GE Nuclear Energy

**ABWR
Design
Control
Document**

Design Control Document Table Of Contents

Chapter 20

**Figure 20.3.15-1 Compressed Gas Systems Interconnections
(Response to Question 430.217)**

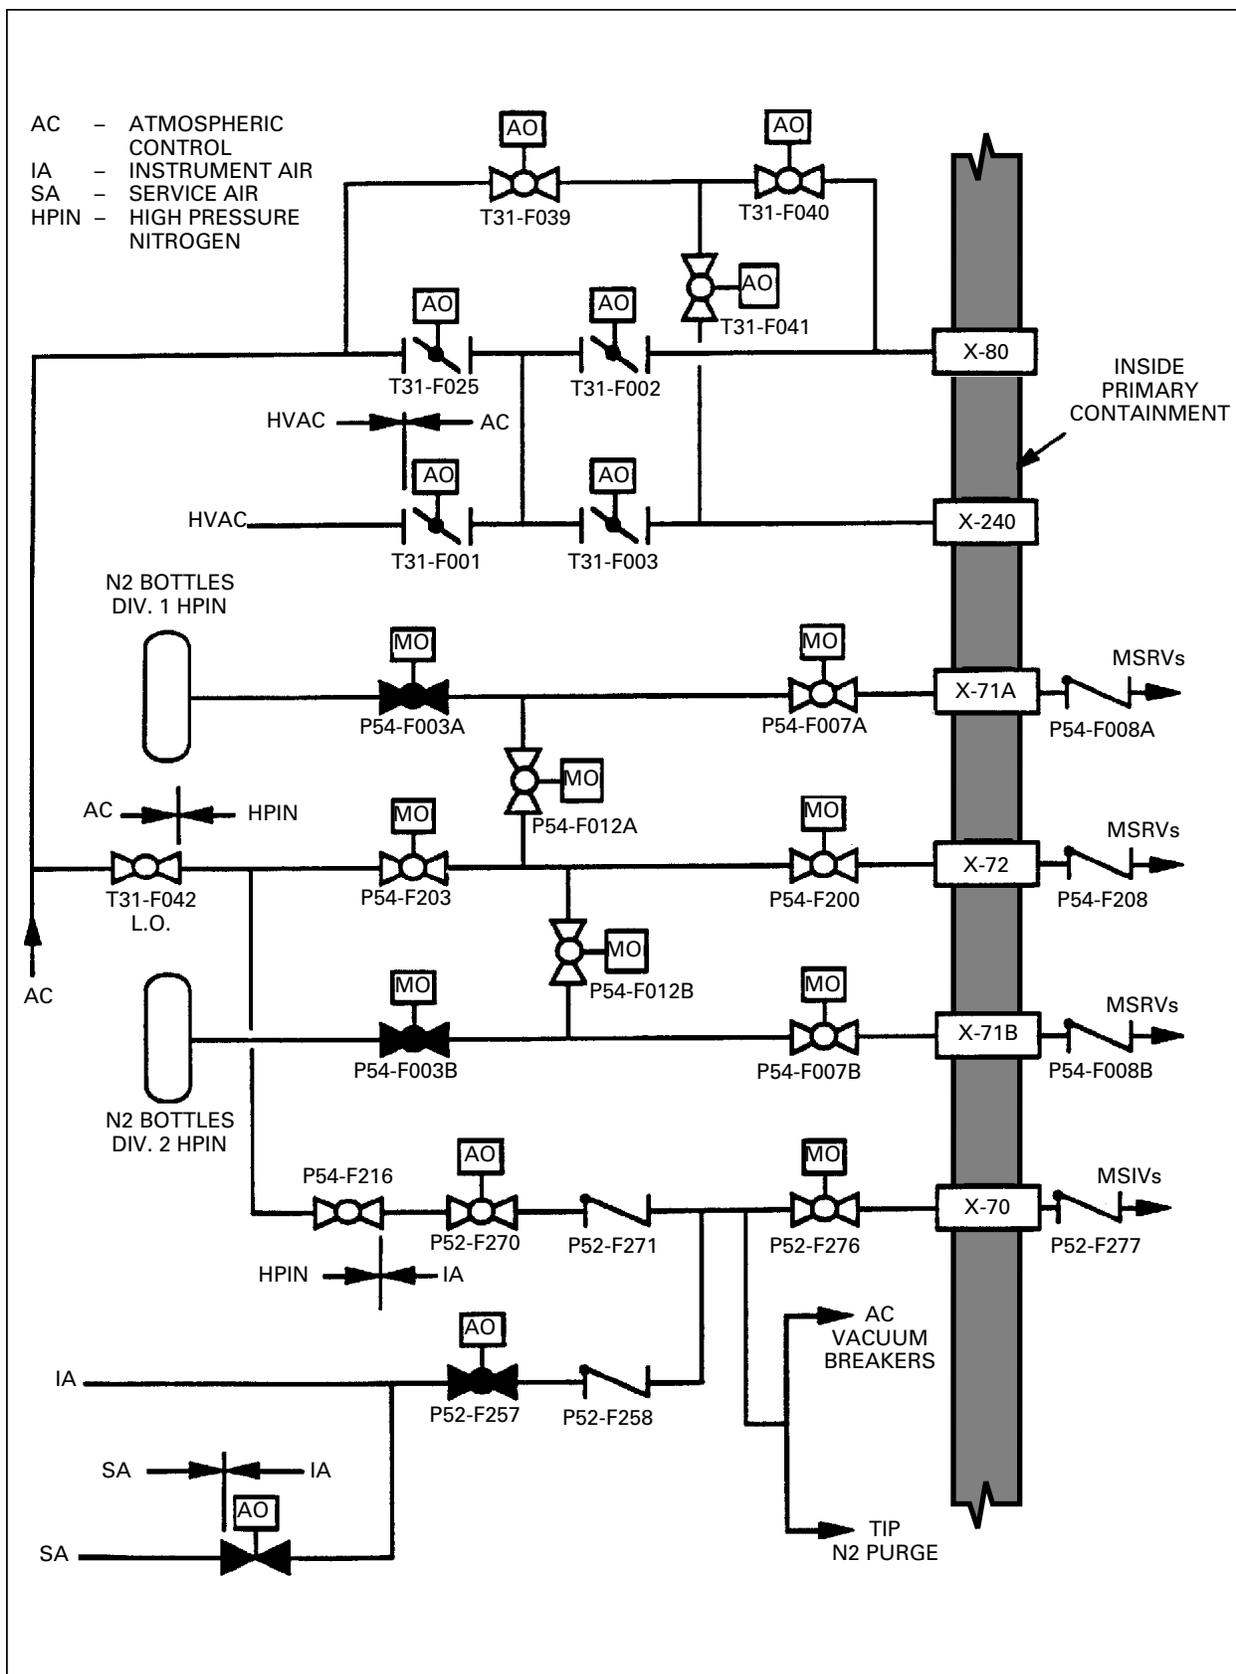
ABWR SSAR Figure 6.7-4 shows only one motor-operated isolation valve on each of the tie lines between each safety-related division and the common non-safety-related division of the high pressure nitrogen gas supply system (MO-F012A and B). The tie piping portion between the two isolation valves is presumably non-safety-related. Explain how essential nitrogen demand will be met during a situation when there is a pipe rupture in one safety-related division (initiating event), single active component failure in the other safety-related division (e. g., isolation valve on the applicable tie line is open) and a pipe break in the non-safety-related portion of the tie lines (if there is such a portion). Alternately, provide two safety-related automatic isolation valves in series on each tie line. (9.3.1, 6.7)

Contrary to what has been stated in ABWR SSAR Subsection 6.7.1, there is only one non-safety-related continuous nitrogen supply portion common to the two essential supply divisions (See Figure 6.7-1). Correct Subsection 6.7.1 as appropriate and discuss the effect of loss of nitrogen supply via the non-safety-related portion to all the equipment and components identified in SSAR Section 6.7.1 (e. g., Pneumatically operated valves and instruments inside the primary containment vessel) during normal operation. Clarify whether the pneumatic accumulator which provides the backup operating gas for the main steam isolation valve (See SSAR Subsection 5.4.5.2) is safety-grade for each valve. If not, justify the design. (9.3.1, 6.7)
